**ADDENDUM NO. 3**

**PROJECT: 5524**  
**February 5, 2024**

**BAKERSFIELD CITY SCHOOL DISTRICT  
MUNSEY ELEMENTARY SCHOOL  
HVAC REPLACEMENT  
3801 BRAVE AVENUE  
BAKERSFIELD, CA 93309**

**DSA APP# 03-122489**

Sheet No.:  
**A2.21**  
Release: ADDENDUM 3  
11/28/22

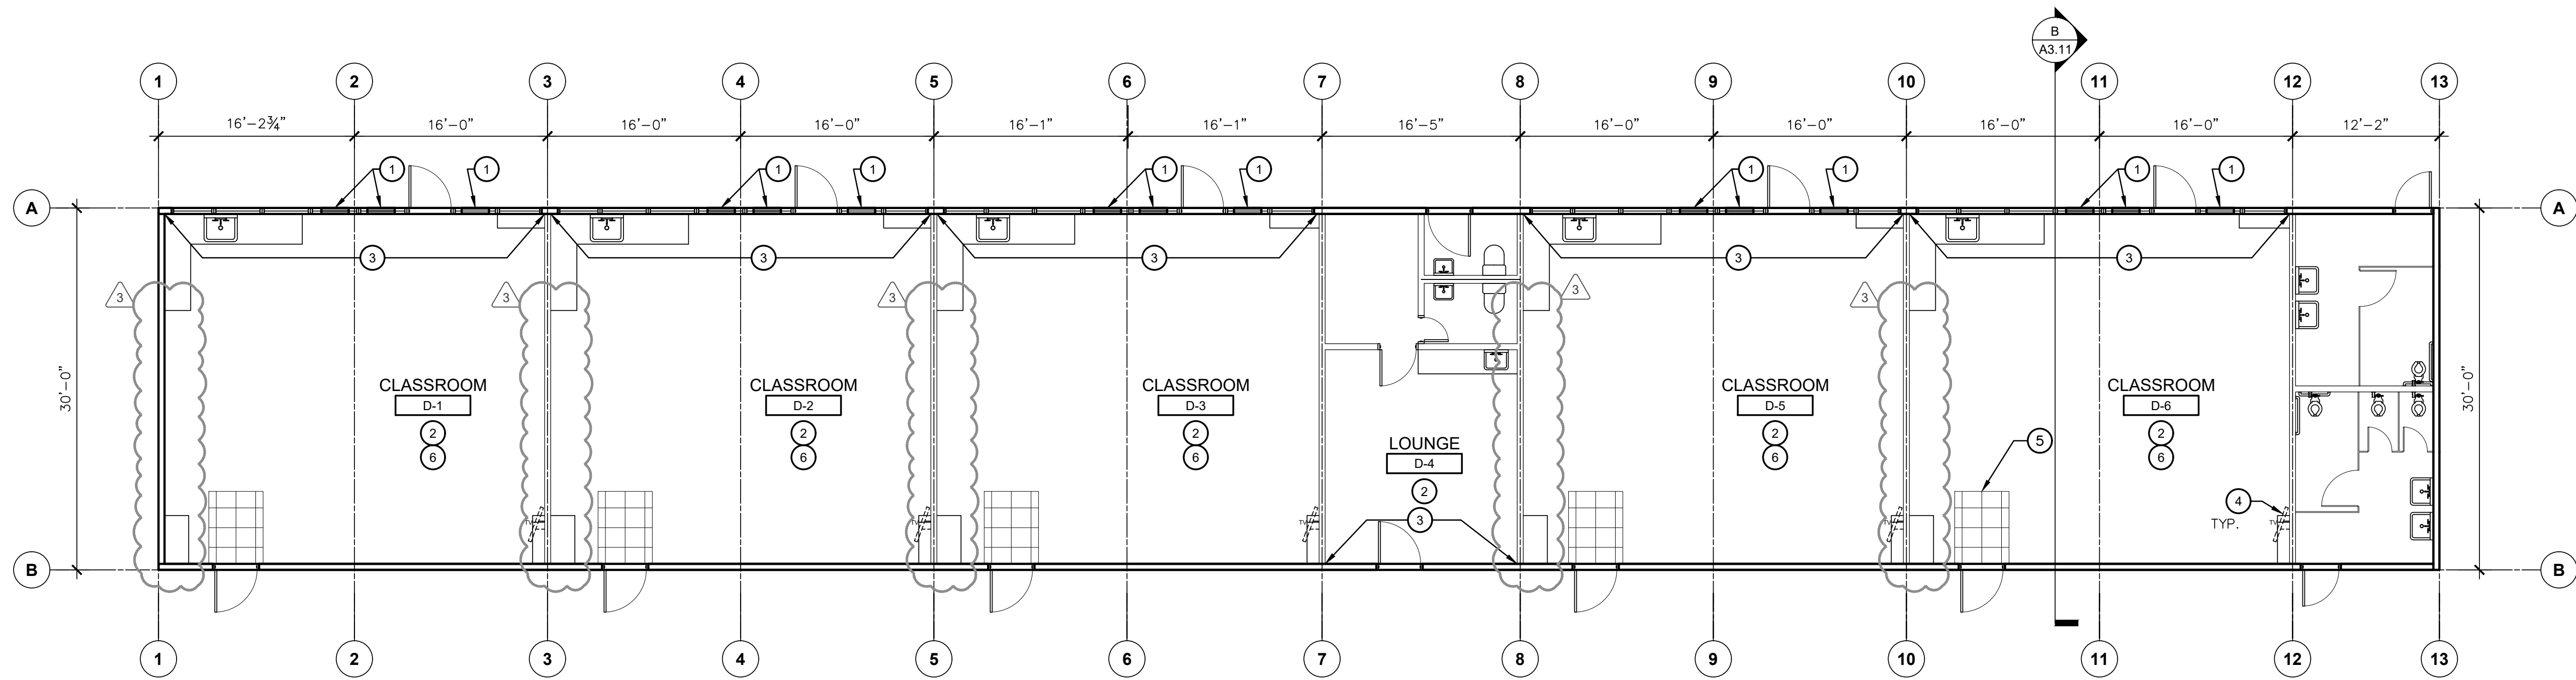
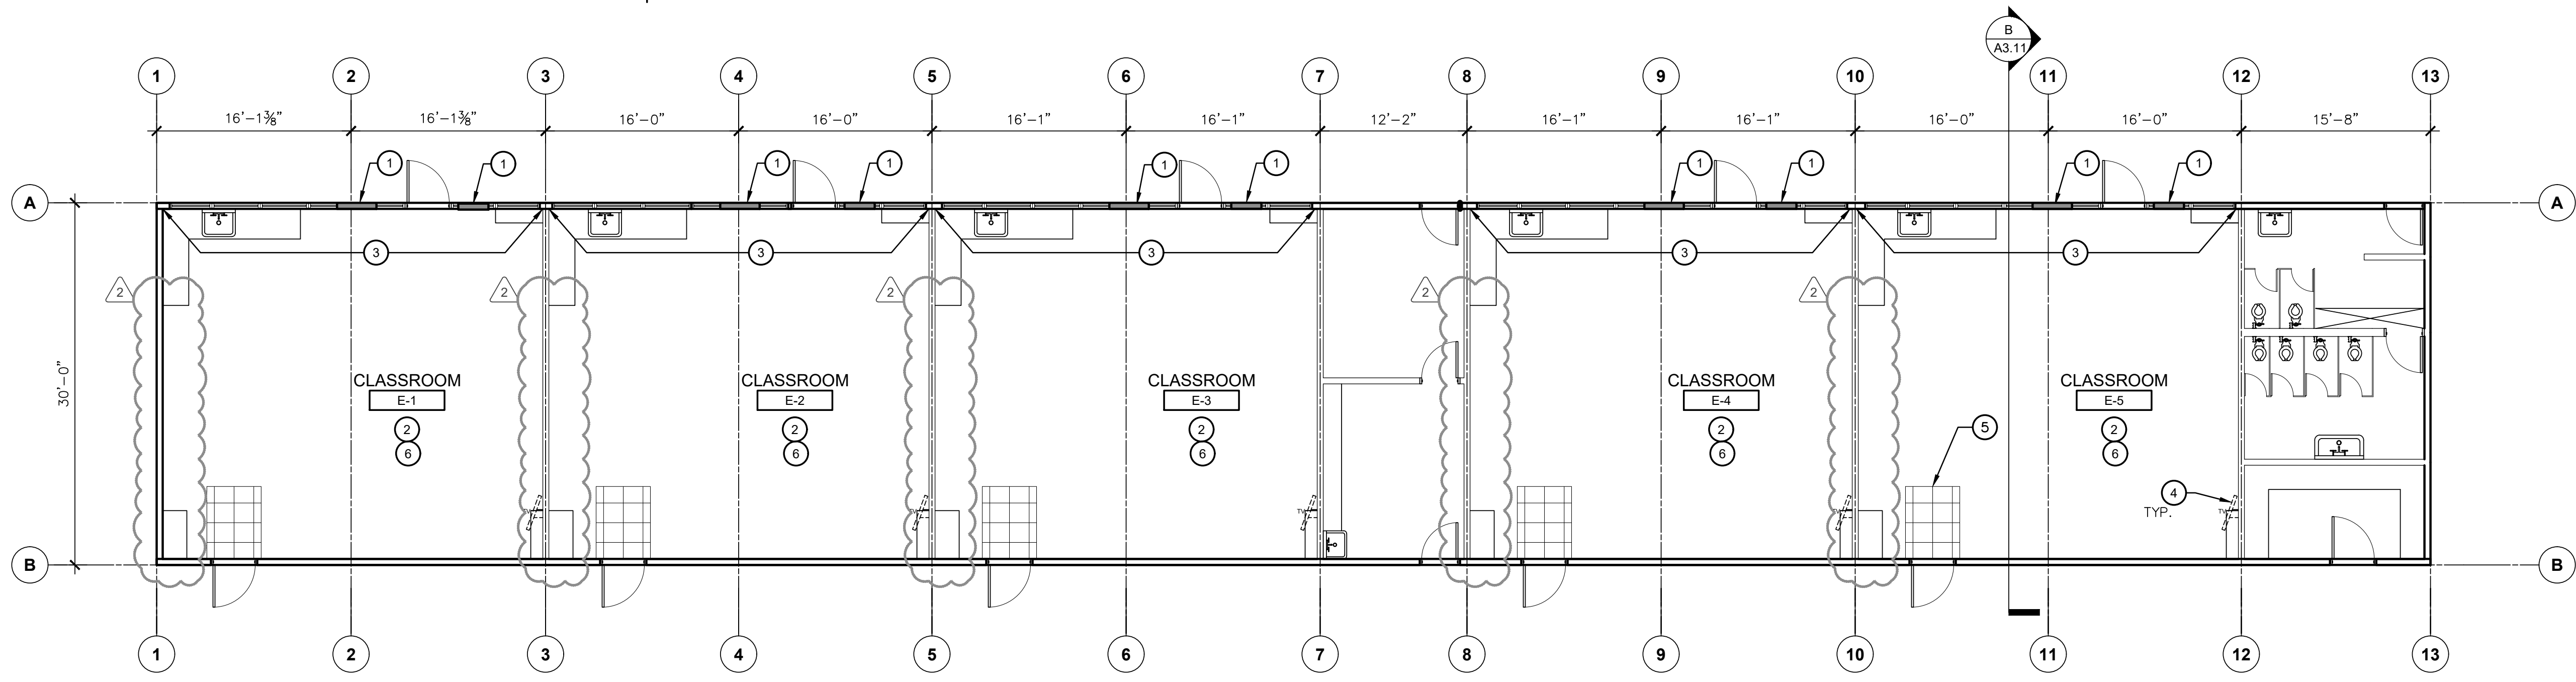
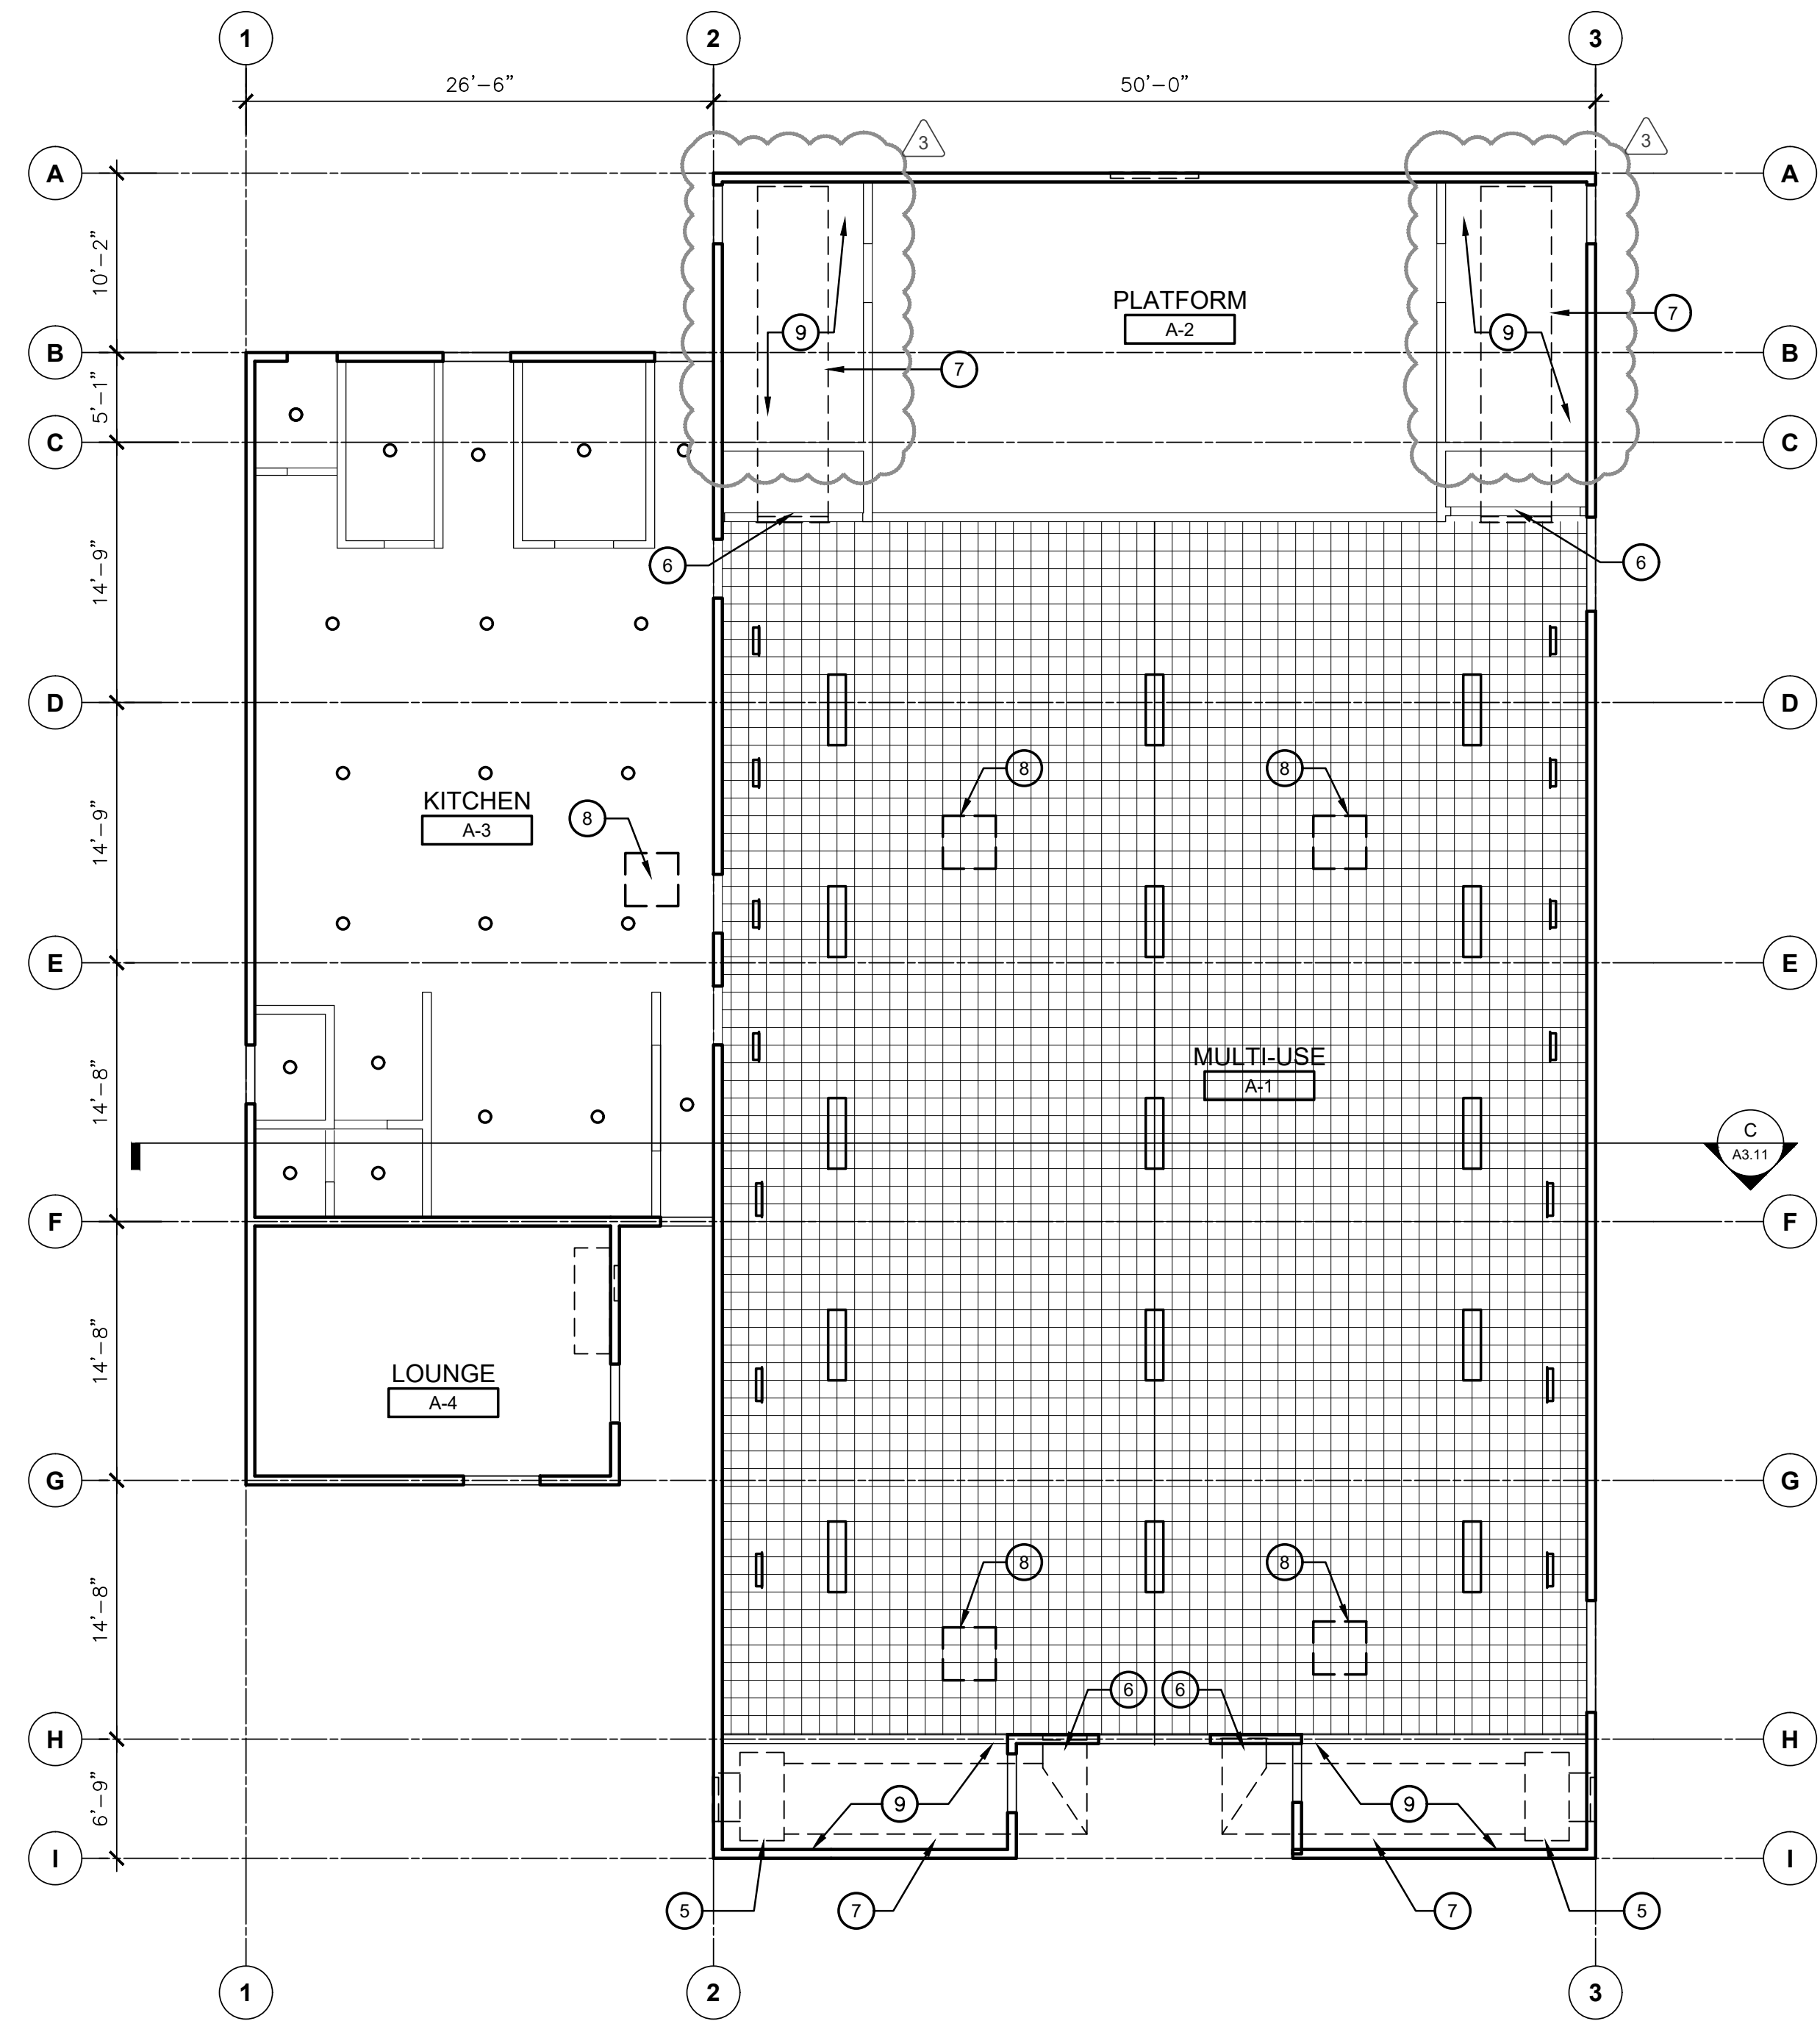
29. Note: the wall finish within classrooms is a plywood finish, not drywall.
30. Provide asphalt sawcut and demolition 5' beyond the limits of the new asphalt paving as shown on The Partial Site Plan on A2.21.

14. Recompact the top 12" of native soil to 92% compaction.
15. Expand asphalt patch 5' beyond the new asphalt limits as shown on The Partial Site Plan on A2.21. Demo Contractor to provide clean saw-cut line.

- 3.07 Sheets A2.10, A2.11, A2.20, and A2.21 have been revised to indicate the removal of a portion of existing cabinets at each of the classrooms.
- 3.08 Remove existing hydronic piping on covered walkway roof between building A and C. The district will assess the condition of the roof after piping is removed to determine if foam roof re-coating will be needed.
